Addendum No. 4

Reference: Unified State Laboratory – Module 2
Department of Public Safety
Department of Health
Department of Agriculture and Food
DFCM Project No. 13020300

Addendum #2

PROJECT NAME: Unified State Laboratory Module 2

AE303
VOLUME 1

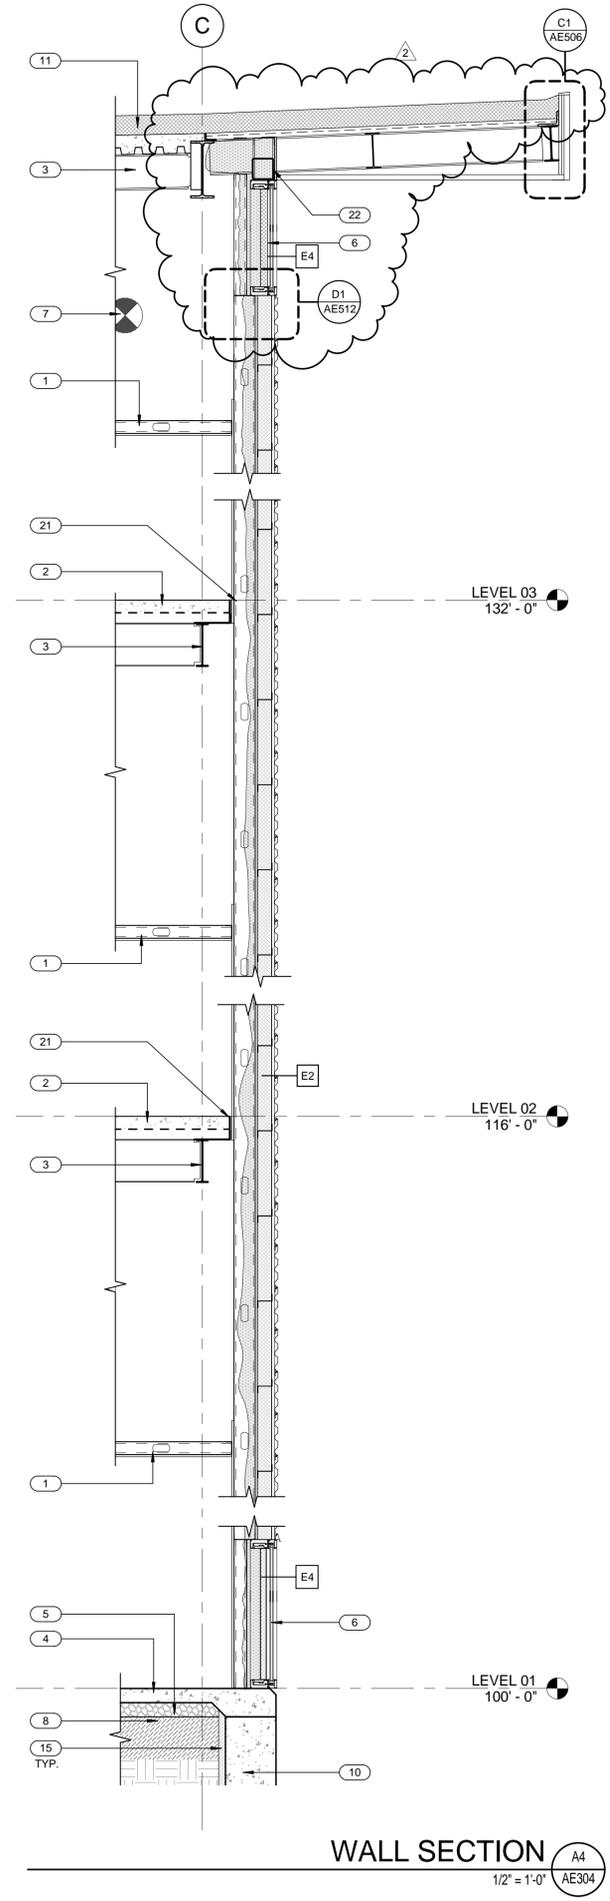
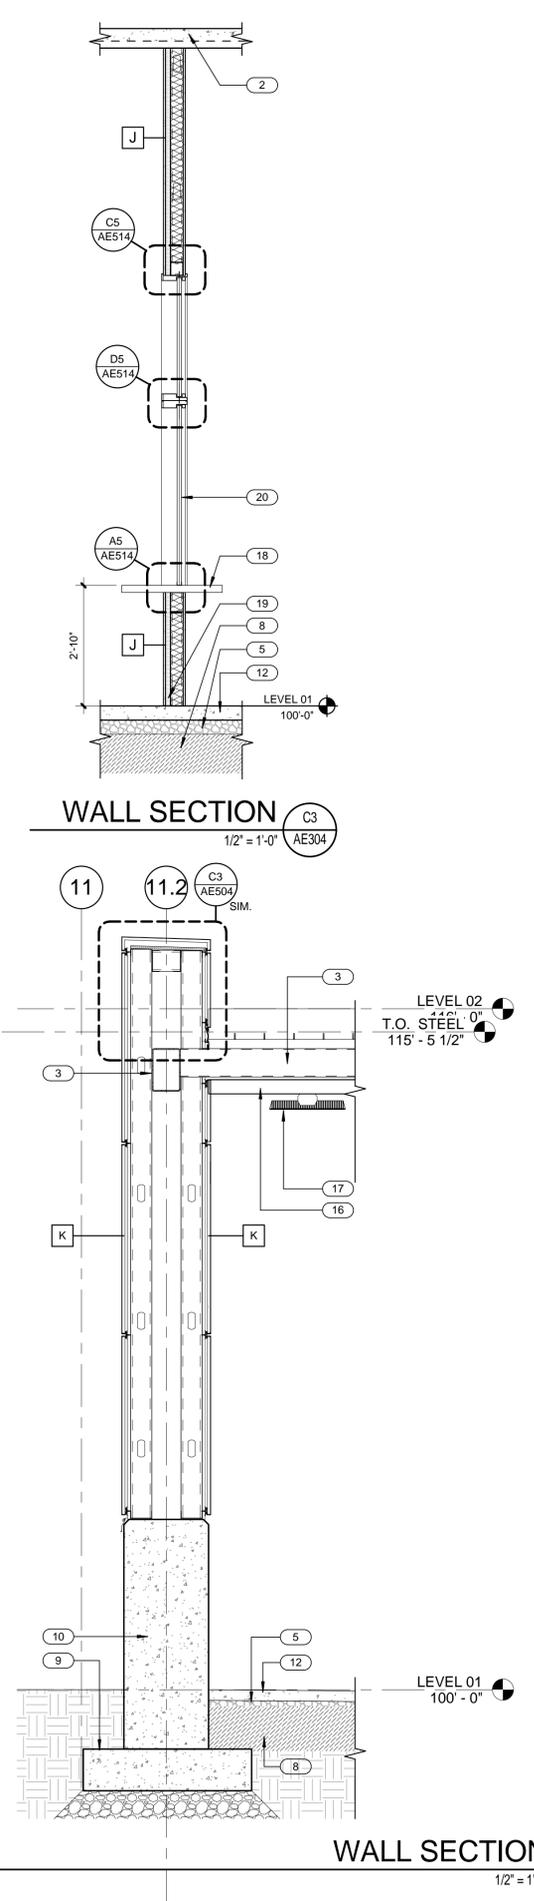
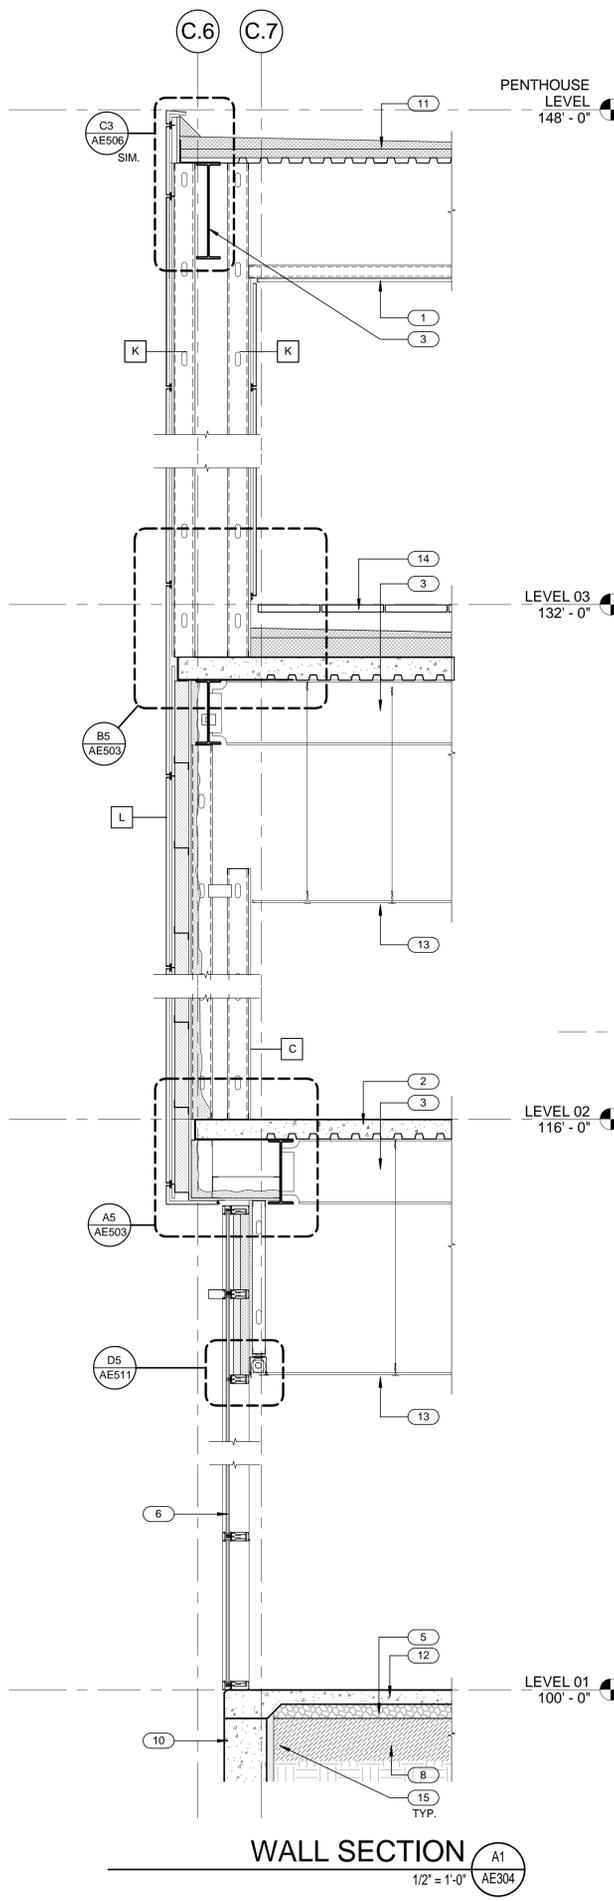
2. AE101C: Added misc items.
3. AE205: Missing sheet issued.
4. AE303: Updated wall sections.
5. AE304: Updated wall sections.
6. AE402: Revised elevations.
7. AE506: Revised detail.
8. AE508: Revised details.
9. AE512: Added detail.
10. AE540: Added details.
11. AE604: Added call outs.
12. AE605: Added call outs.
13. AE610: Revised schedules.
14. See attached Structural, Mechanical & Plumbing drawings.

LEVEL 1 MECHANICAL PLAN AREA B
1/8" = 1'-0" MH101B

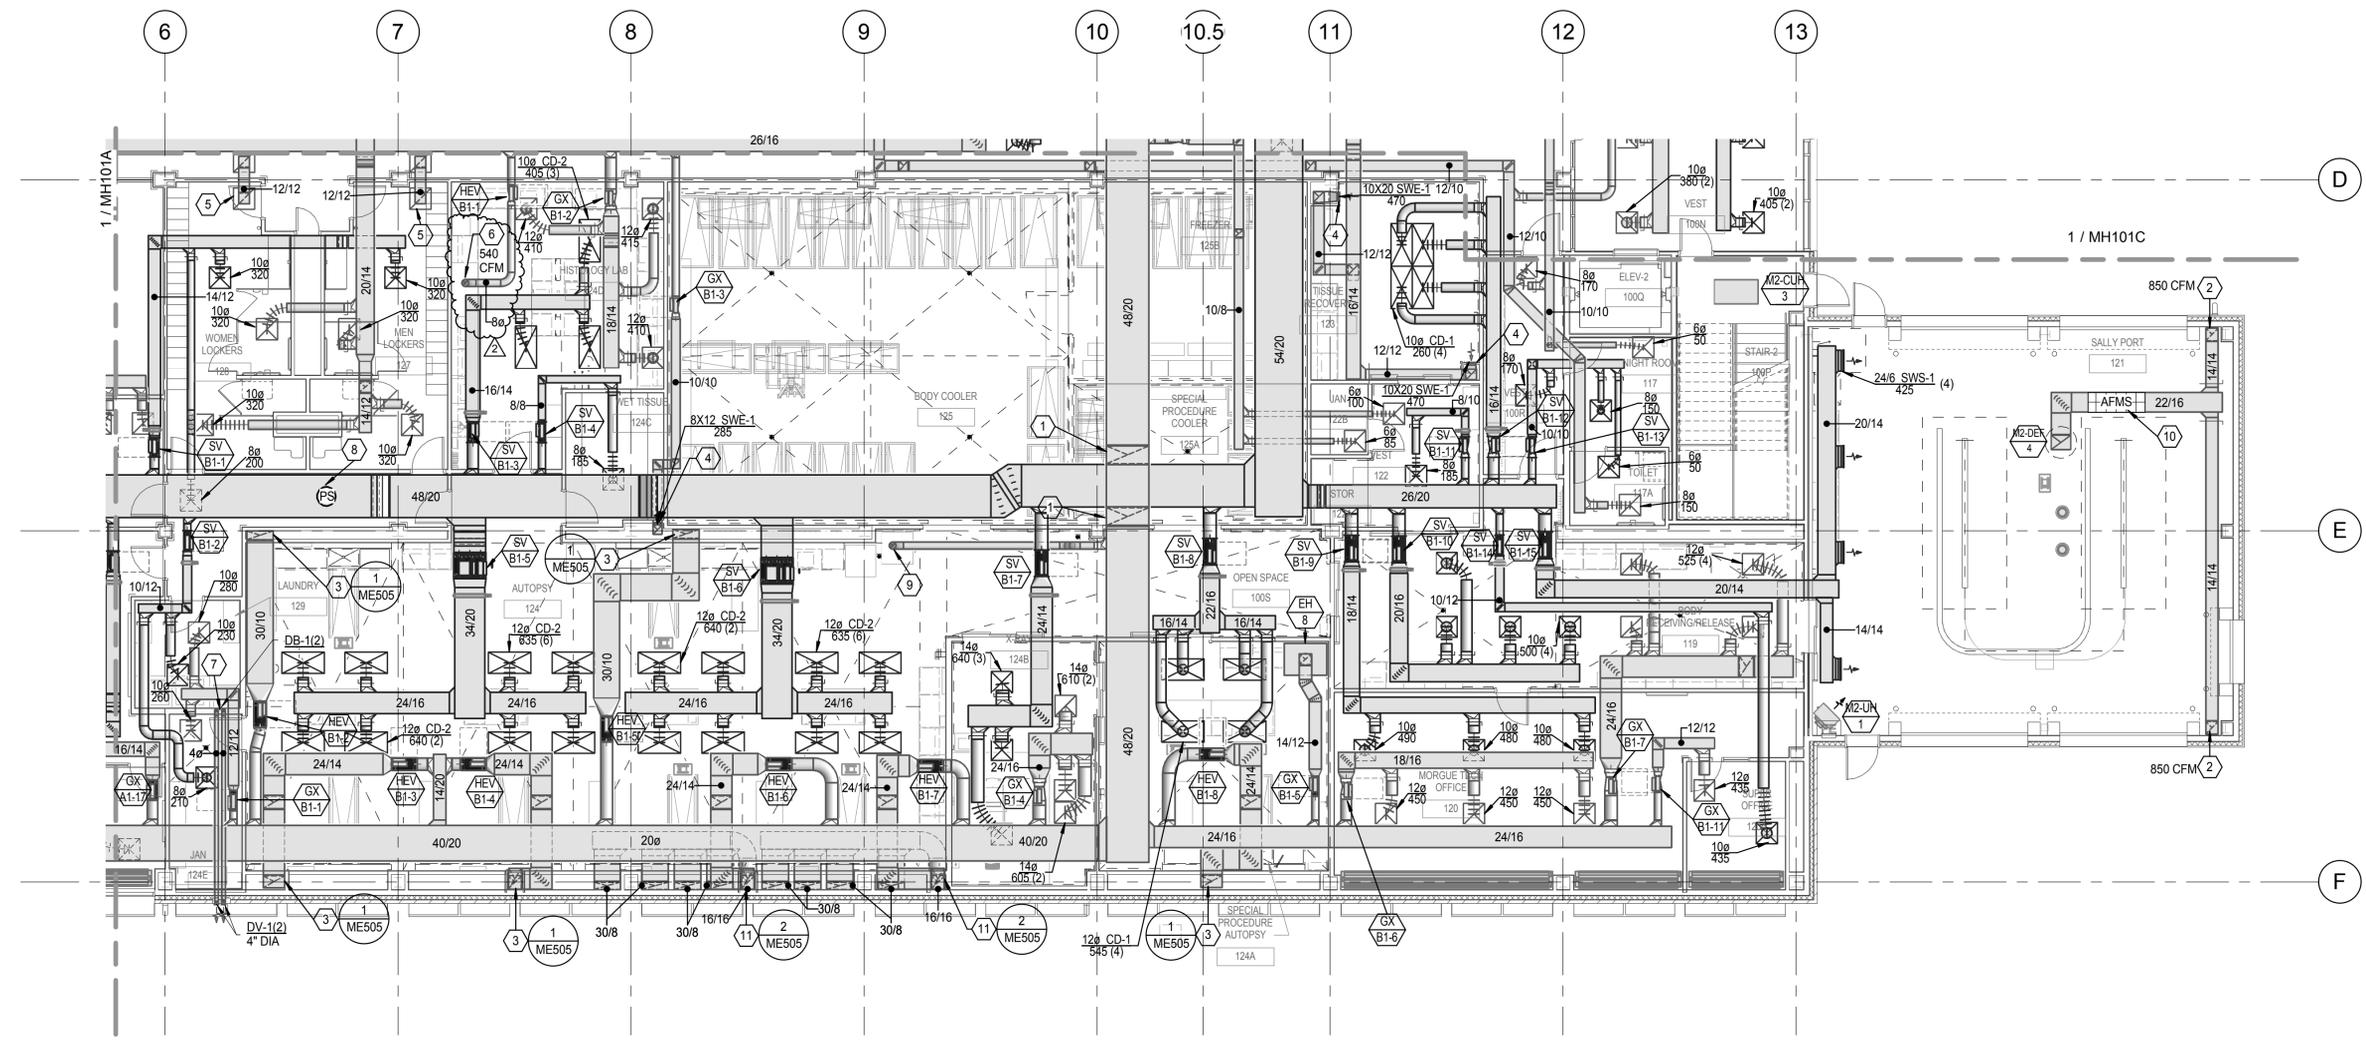
1. Revise exhaust duct routing connected to HEV-B1-1 in Histology Lab 124D to match revised fume hood location.

PE103A

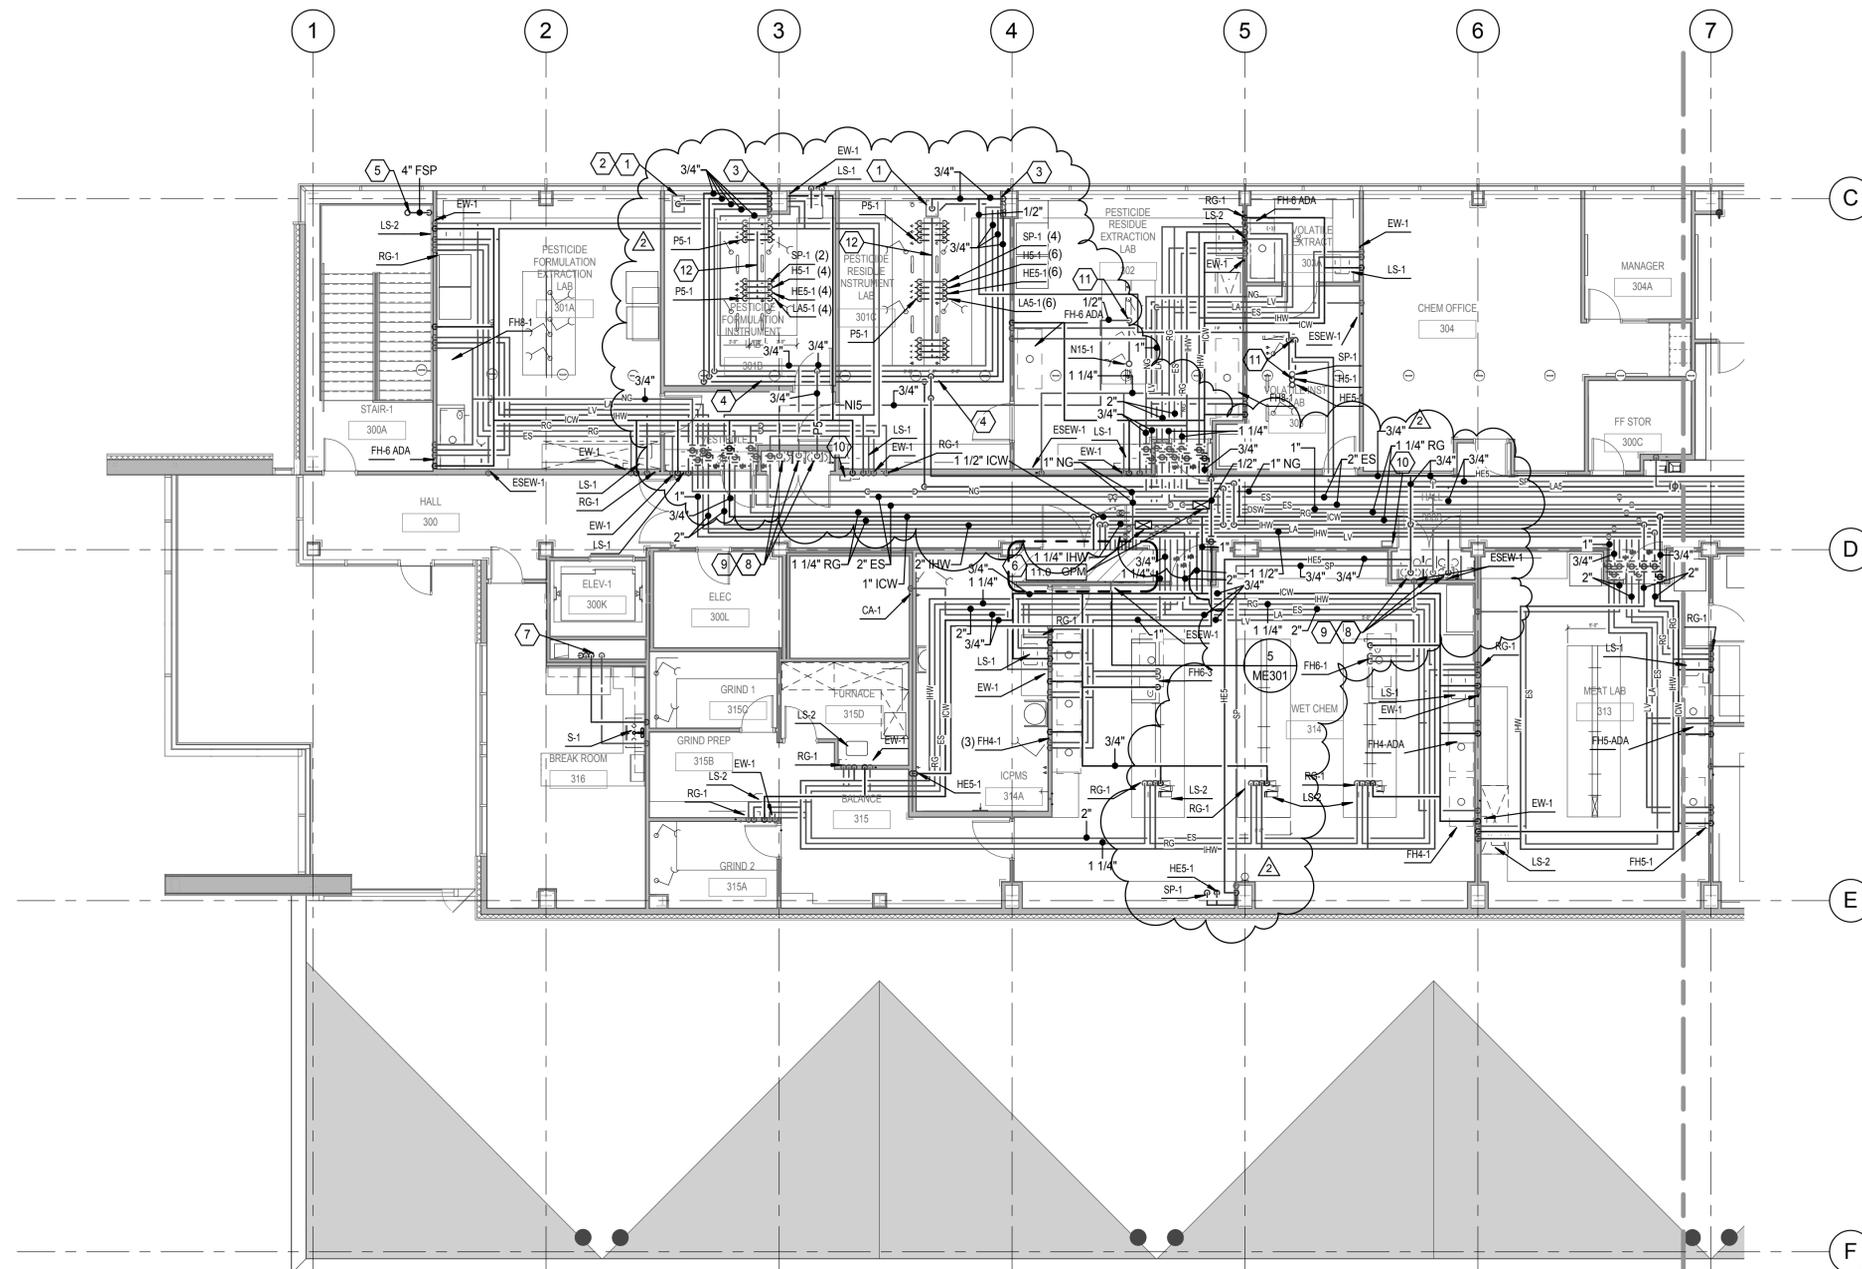
1. Pesticide Formulation Instrument Lab-301B and Pesticide Residue Instrument Lab-301C: Add P5-1 outlets and P5 piping serving these labs. Add Keyed Note indicator to SP tanks in grid 3 tank storage closet.
2. Change SP piping in corridor to originate from tanks in closet near grid 6. Add Keyed Note indicator to SP tanks grid 6 tank storage closet.
3. Add ES water supply piping to ESEW-1 in Wet Chem 314.
4. Add SP piping and SP-1 outlet in Wet Chem 314.
